Re: Professional Engineer's Certification of Permanent Control Measure
Flying Horse North Filing No. 3, Pond B

This letter serves as a Pond Certification for the constructed Full Spectrum Detention Facility "Pond B" located in Flying Horse North Filing No. 3. The permanent control measure is located within Tract B which is located within the southwest corner of the Flying Horse North subdivision with access from the west termination point of Allen Ranch Road, adjacent to Lots 19 and 20, Filing No. 3, El Paso County, Colorado.

POND B [CONSTRUCTION DRAWINGS PLAN SHEETS 28-32]:

DETENTION BASIN OUTLET STRUCTURE DESIGN

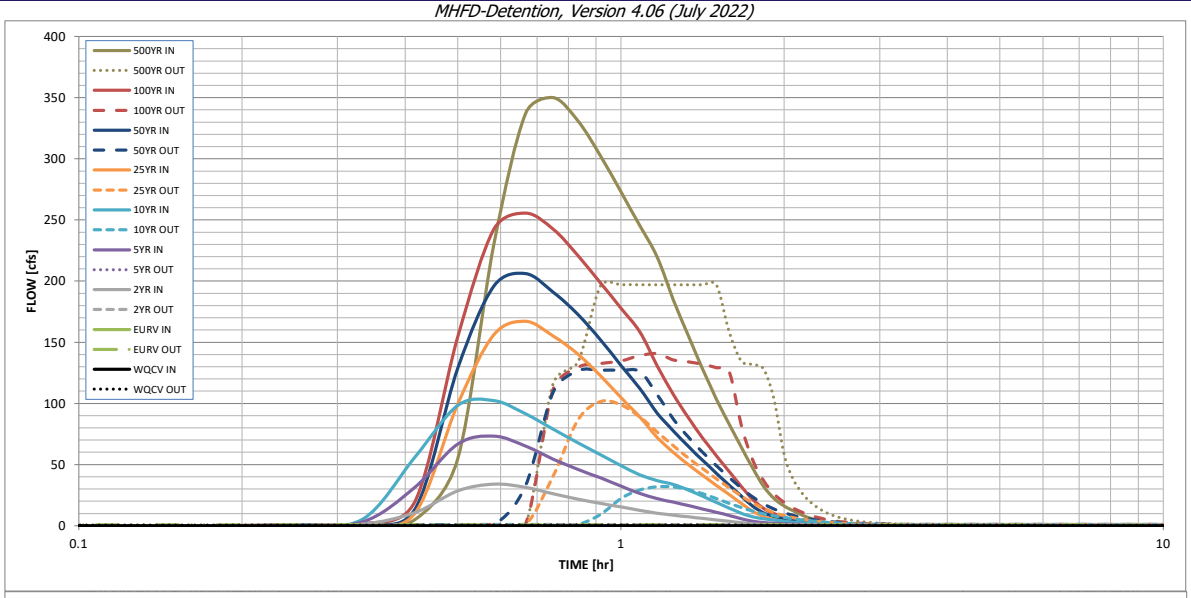
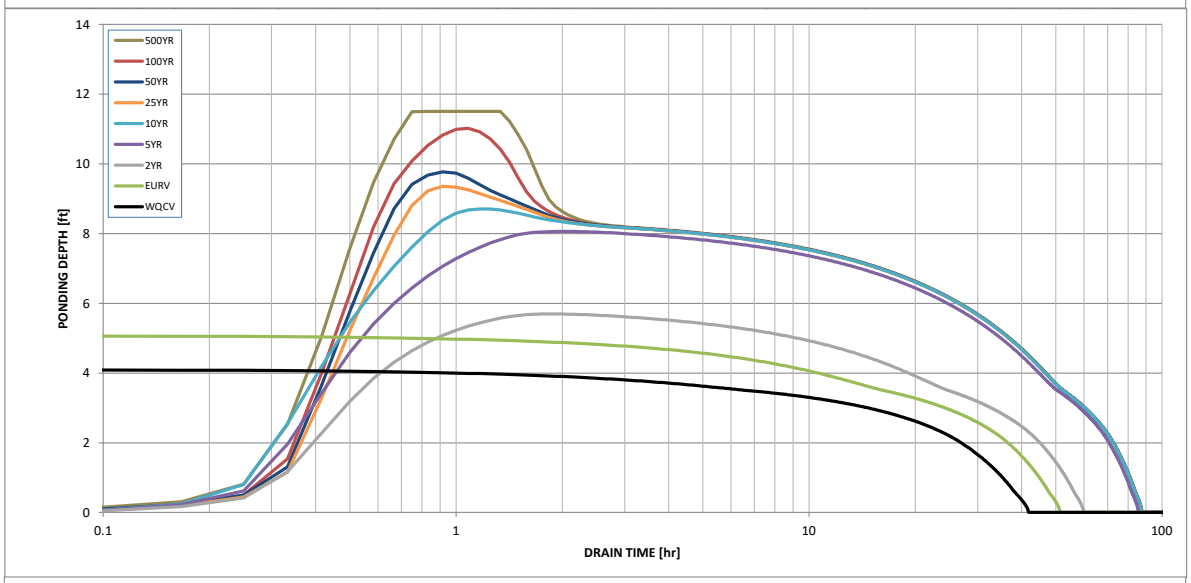
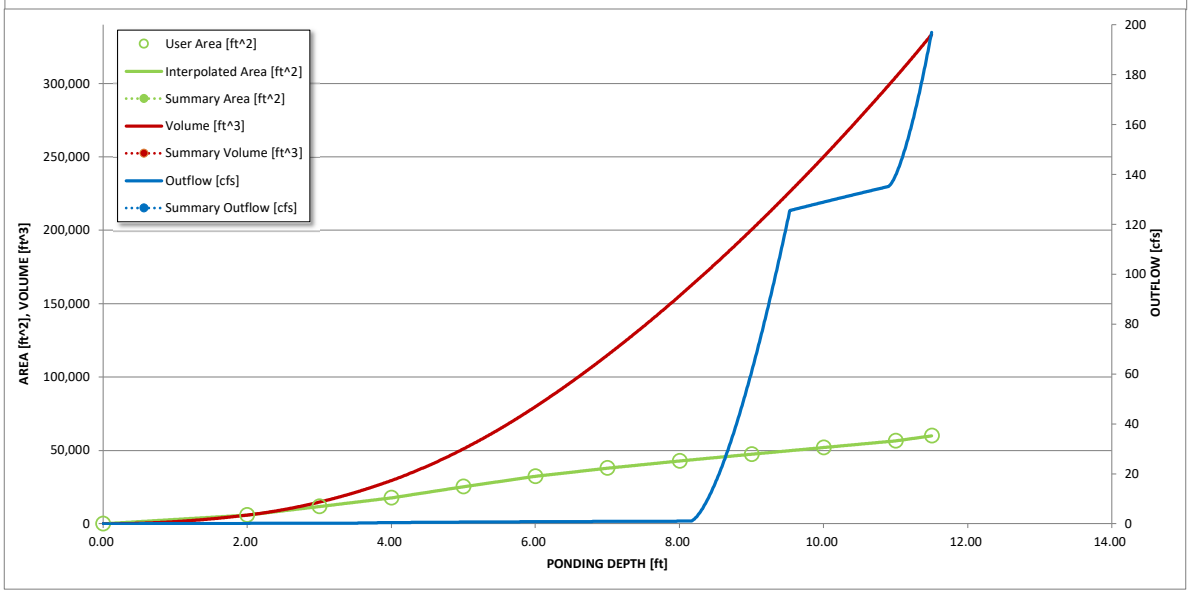
- Outlet Structure
  - Restrictor plate is installed approximately 1' too low. Install per approved plans. ***A revised, redlined as-built is now provided for the installed condition and verification that the pond functions as intended and per criteria is verified by the Engineer of Record.***

- Lowest orifice is ~10" too high. 2nd orifice is likely too high. Fix the orifice hole elevations to match plans
    or have an engineer re-run the calcs with the orifice holes as-is to see if the calcs work. ***A revised, redlined as-built is now provided for the installed condition and verification that the pond functions as intended and per criteria is verified by the Engineer of Record.***

- Spillway
    - Spillway is two feet short in length along the crest. Install per approved plans or consult the Engineer of Record (see Note 1). ***A revised, redlined as-built is now provided for the installed condition and verification that the pond functions as intended and per criteria is verified by the Engineer of Record.***

REVISED ORIFICE PLATE DESIGN, AS-BUILT 10/6/2026 VERIFIES THIS PLATE DESIGN IS INSTALLED.

RESTRICTOR PLATE ADJUSTMENT VERIFIED IN FIELD 10/6/26.

WITHIN CONSTRUCTION TOLERANCES, APPROVED BY ENGINEER OF RECORD.
